1 **Response to reviewer 1: ‘Automated ArcticDEM iceberg detection tool:**
2 **insights into area and volume distributions, and their potential application to**
3 **satellite imagery and modelling of glacier-iceberg-ocean systems’ by Shiggins**
4 **et al.**

433 **Response to reviewer 2: ‘Automated ArcticDEM iceberg detection tool:**
434 **insights into area and volume distributions, and their potential application to**
435 **satellite imagery and modelling of glacier-iceberg-ocean systems’ by Shiggins**
436 **et al.**

100 *Draft figure 1. Google Earth Engine ArcticDEM v3 strip data availability (July-*
101 *October) for Greenland's calving margins (Goliber et al., 2022) and the extent of all*
102 *marine/lake/shelf terminating glaciers extent in the remainder of the Arctic (RGI v6;*
103 *Pfeffer et al., 2014).*

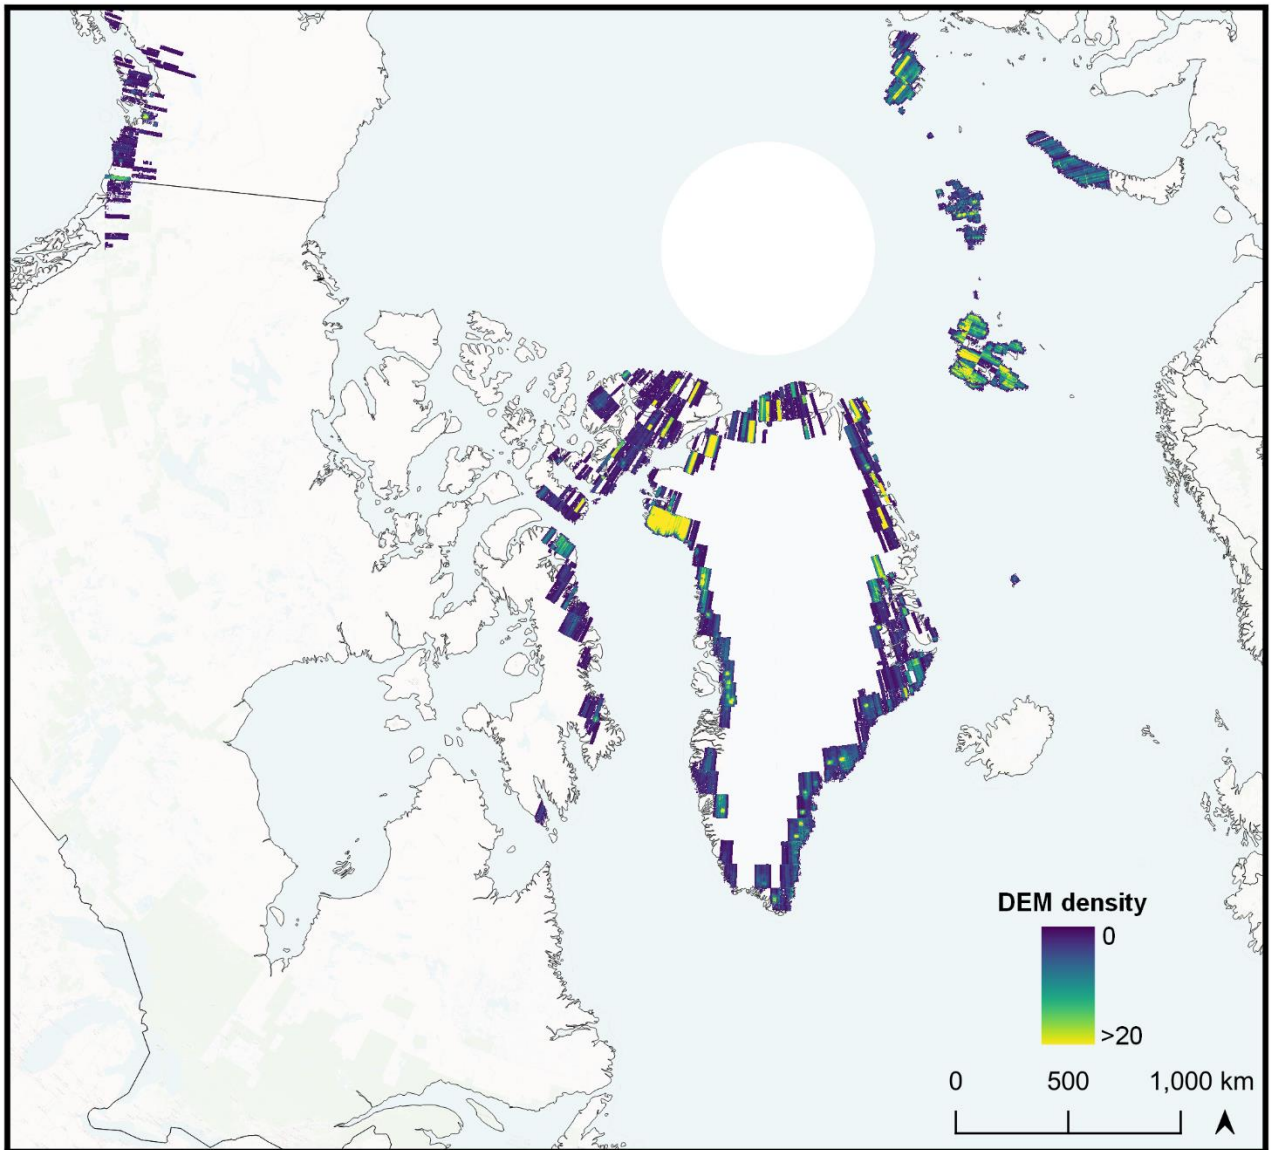
54 2. The authors make a couple of references to this method having the potential
55 to be upscaled across the full continent. However, they also suggest that
56 there would need to be good enough data coverage for this. Please can the
57 authors clarify whether there is enough data for pan-Arctic application or not?

136 2. (L25): Is there sufficient data coverage for a pan-Antarctic study? If not, I probably
137 wouldn't say this.

- 58 • We have created a draft supplementary figure (see Draft Figure 1
59 below) which shows the coverage of ArcticDEM strip data on the pan-
60 Arctic scale using locations identified as marine terminating glaciers for
61 non-ice sheet and ice sheet glaciers (from the Randolph Glacier
62 Inventory (RGI) v6 and Goliber et al. (2022) respectively). The map has
63 been created by identifying the footprints of ArcticDEM strip data where
64 there is overlap within 5 km of the point locations provided by Goliber
65 et al. (2022) for Greenland, and having any overlap with RGI glacier
66 outlines whose metadata show them as being either lake terminating,
67 marine terminating or shelf terminating. This figure will be included as
68 supplementary data in the revised manuscript. However, as RGI data
69 use a benchmark of glacier outlines observed at near to 2000 as
70 possible and some glaciers have now retreated into proglacial lakes

71 (e.g. in Iceland) or changed their terminal environments, this map may
72 not include ArcticDEM coverage of these glaciers. Consequently, we
73 have also created summary maps showing all ArcticDEM data
74 coverage irrespective of whether they cover glaciers or not.

- 75 • To allow users to get a quick impression of data availability for a given
76 ROI we have now included new functionality within the GUI to view a
77 series of summary maps showing ArcticDEM coverage. This includes:

- 78 1. Map showing July-October coverage for known calving glaciers
79 (Draft Figure 1; i.e. data least likely to be affected by solid
80 melange/sea ice).

- 81 2. Map showing all ArcticDEM coverage for known calving glaciers
82 irrespective of acquisition time.
 - 83 3. Map showing all ArcticDEM coverage from the entire dataset
84 irrespective of whether a glacier is thought to be there or not.

- 85 4. As map 3, but for the months July-October.
- 86 • Further functionality to allow users to filter DEMs by month of
87 acquisition has also been added to the GUI. The analysis workflow for
88 this revised GUI has otherwise not been changed. The revised GUI for
89 inclusion can be accessed at the following link:
90 ([https://code.earthengine.google.com/ad11c00c37b7ad88e28c4493ee
91 6eec64](https://code.earthengine.google.com/ad11c00c37b7ad88e28c4493ee6eec64)).

- 92 • It is worth noting that these maps show where ArcticDEM data are
93 available irrespective of the quality of the DEM data. Consequently,
94 they do not indicate that all of the DEMs will be of sufficient
95 quality/coverage to allow it to be used for analysis.

112 *Draft figure 2. New location maps for the study sites with changed imagery*
113 *(ArcticDEM from Sentinel-2) and ROI outlines in black.*

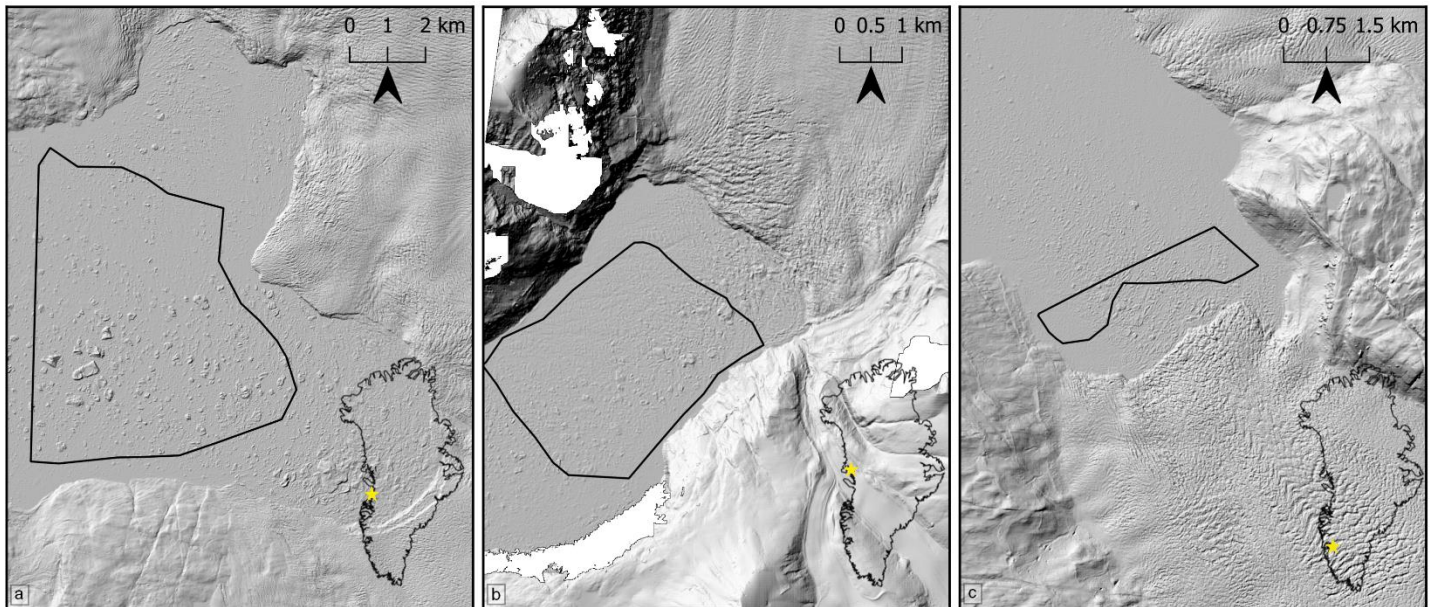
104 3. It would be good to see some figures showing what the DEM data looks like.
105 You may have readers who have not worked with the Arctic DEM before, and
106 it makes your workflow hard to understand without seeing some
107 visualisations. Please can the authors add a figure (or two) where they deem
108 it most appropriate.

213 13. (L129): Tidy up these figures where possible. The 'a' 'b' 'c' labels, north arrows,
214 and scale bars would be better on a white background rather than a translucent
215 background. Could you also make all the ROI outlines either green or red?

219 14. (L133): I would say this bounding box is green? Comment on the subset map
220 also.

109 We will replace our figure location maps that used Sentinel-2 imagery with hillshaded
110 ArcticDEM data to provide readers with an indication as to what the DEM data look
111 like. See below for the new draft location figure to replace Figure 1.

- 216 • Draft Figure 2 has been created in response to main comment 3 (RL04). This
217 has been changed to show examples of ArcticDEM imagery and the ROI
218 outlines have been changed to black for colour accessibility and consistency.

- 221 • Colour will be changed to black. See Draft Figure 2.

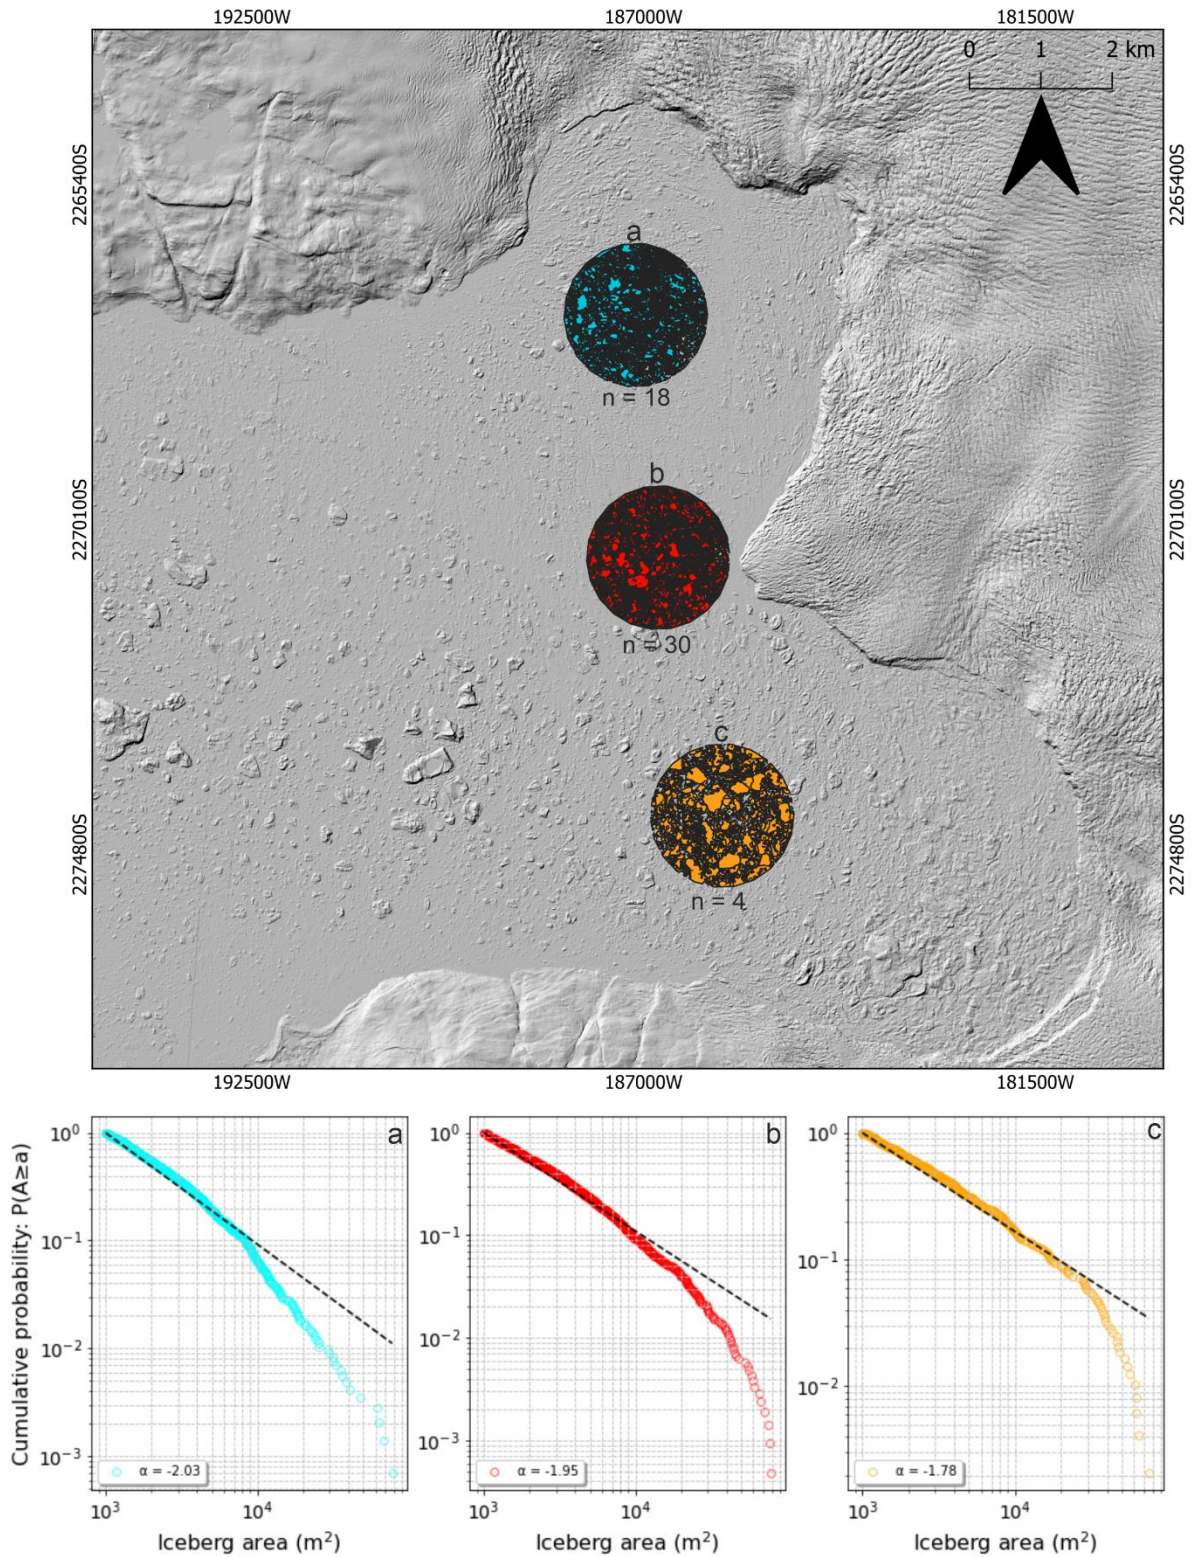
- 445 1. Availability of ArcticDEMs and picking the right ROI. I was able to run the
446 code on SKJI without much trouble and could also approximately reproduce
447 some of the distributions in the paper (e.g. something similar to those in Fig
448 6). However, when I tried to explore other random glaciers around Greenland
449 I struggled to find ones with any available ArcticDEM scenes. I randomly tried
450 ~10 or so glaciers in different regions and only 2 identified any ArcticDEM
451 scenes (2 scenes each) for the ROIs that I picked. It was not clear to me from
452 the manuscript how exactly to pick the ROIs and I tried to emulate the shapes
453 provided in Fig 1 but realized I had no further knowledge how these were
454 determined. This may be part of the reason why I couldn't detect more DEM
455 scenes. I was also struck by the fact that picking slightly different ROIs in front
456 of SKJI resulted in detecting a different number of scenes and also in

457 somewhat different slopes for the area distributions. I appreciate that a
458 comprehensive account of where ArcticDEM scenes are available may be
459 beyond the scope of this study, but the lack of information in this regard limits
460 the utility of the product. Relatedly, it would be helpful to have some practical
461 guidance of how to draw the ROI polygons to best harness the strengths of
462 the algorithm. Finally, a discussion of how much the results depend on the
463 number of scenes available would be helpful. This could for example be
464 explored by running the analysis on subsets of the SKJI scenes and showing
465 the resulting spread in power law slopes, or similar?
466

- 475 • With respect to the point raised regarding how slightly different ROI definition
476 impacts results, as suggested by the reviewer we have conducted analysis on
477 3 ROI subsets for SKJI in front of the northern, central and southern regions

478 of the glacier (see Draft Figure 3). For the northern branch, results from 18
479 DEMs available returned a power law slope of -2.03, the middle ROI with 30
480 DEMs returned a power law slope of -1.95, and the southern branch subset
481 had 4 DEMs available returning a power law slope of -1.78. Consequently,
482 there is some variation in both image availability and the α value for each
483 section of the fjord. Understanding what is driving this localised variability is
484 poorly understood and certainly deserves detailed study in and of itself.
485 However, given the potential for changing calving styles through time and
486 variation in space of calving dynamics in front of each terminus region, it is not
487 possible to say here whether these differences arise from data availability or
488 differences in fjord/glacier dynamics. Such analysis would require detailed
489 understanding and analysis of individual glacier dynamics and their spatial

- 491 • As commented upon by the reviewer and highlighted in the response above,
492 choosing different ROIs can lead to variation in the number of DEMs available
493 for analysis. This is especially noticeable at SJKI as the terminus is over 40
494 km long and ArcticDEM strips rarely cover the entire fjord region. We also
495 note that this is likely to have most significant impact on glaciers with long
496 margins (e.g. SKJI, Humboldt, 79N), and will have less of an impact on termini
497 in narrower (e.g. ~2-10 km wide) fjords. To potentially increase data
498 availability across an ice front, the filter threshold defining the lower limit of
499 ROI coverage can be lowered to allow more DEMs to be taken forward for
500 subsequent analysis (default is 80% or 0.8 in the workflow). This is defined in
501 line 220 of the code with a variable name '*imageAreaCoverage*'. However,
502 doing so may lead to less accurate definition of sea level for each image. To

503 clarify this, we will add discussion of Draft Figure 3 in the main text at L503,
504 and will provide full instructions and caveats as part of the GitHub readme. It
505 should also be noted that the new GUI functionality included in response to
506 Reviewer 1's main comment 2 (RL54) will allow users to get an indication of
507 how much ArcticDEM data may be available for different glaciers across the
508 Arctic region.
